1985 RX-7 & 1984 B2000/B2200

SUBJECT Counter Shaft Gear & Lock Nut.

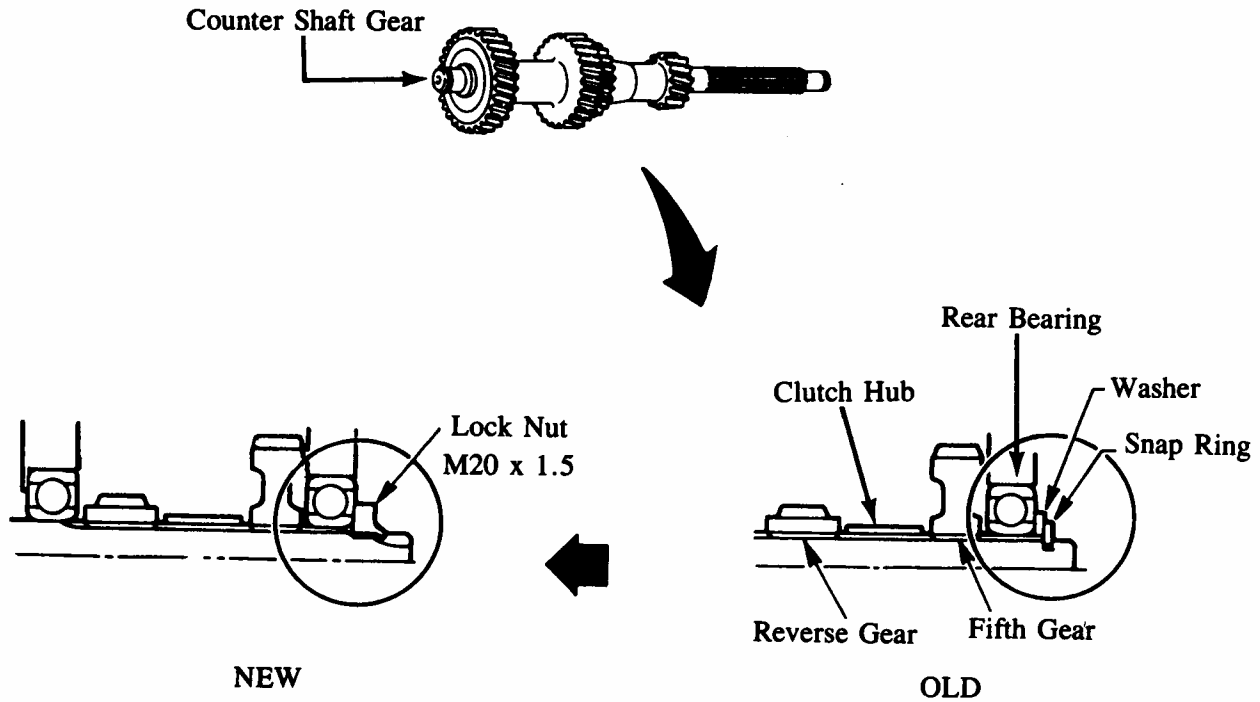
In order to retain the rear bearing on the counter shaft gear more securely, the snap ring has been replaced by a lock nut.

- Stake the lock nut as shown:

- Tighten the lock nut to: 94 – 145 ft-lb
127 – 196 N-m
13 – 20 kg-m
